SUBJECT: Forwards affidavit re revision to proposed amend 105 to license NPF-22 as clarification re average fuel bundle exposure limit for 9x9 fuel.

**SUSQUEHANNA STEAM ELECTRIC STATION
REVISION TO PROPOSED AMENDMENT 105 TO
LICENSE NO. NPF-22 : UNIT 2 CYCLE 6 RELOAD
PLA-3864 FILES A7-8C/A17-2/R41-2**

PROPOSED AMENDMENT No. 105
FACILITY OPERATING LICENSE NO. NPF-22
SUSQUEHANNA STEAM ELECTRIC STATION
UNIT NO. 2

MAXIMUM AVERAGE PLANAR LINEAR HEAT
 GENERATION RATE (MAPLHGR) VERSUS
 AVERAGE BUNDLE EXPOSURE
 SNP 9X9 FUEL
 FIGURE 3.2.1-1

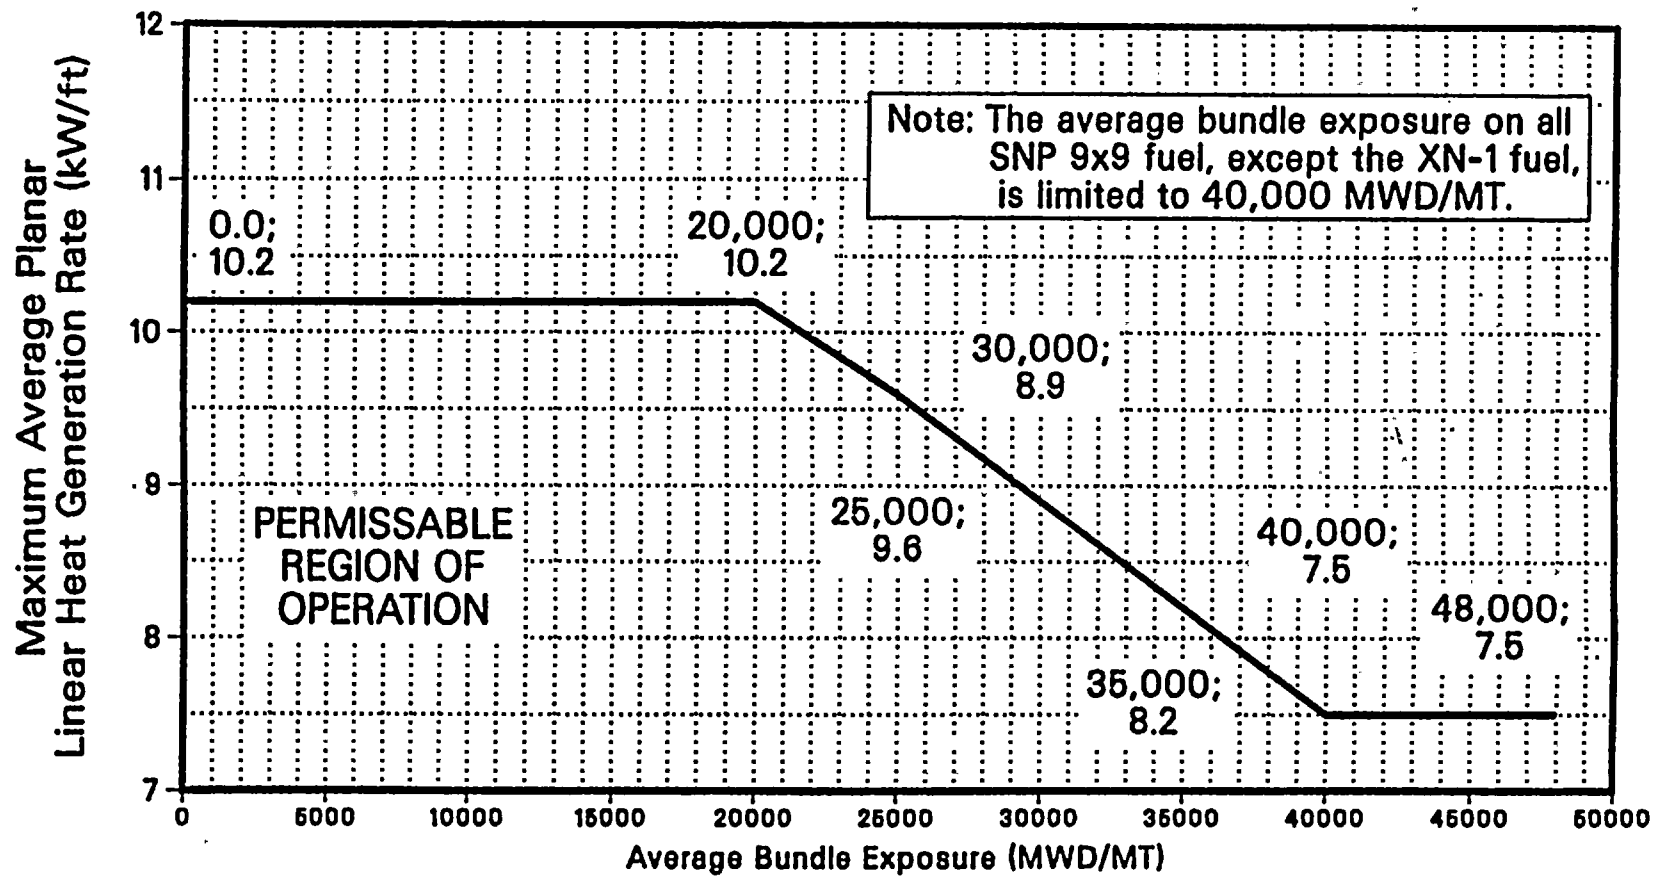
The purpose of this letter is to provide the affidavit requested by your staff for the above referenced PLA dated July 21, 1992. This letter provided a clarification regarding the average fuel bundle exposure limit for the 9x9 fuel (Attached).
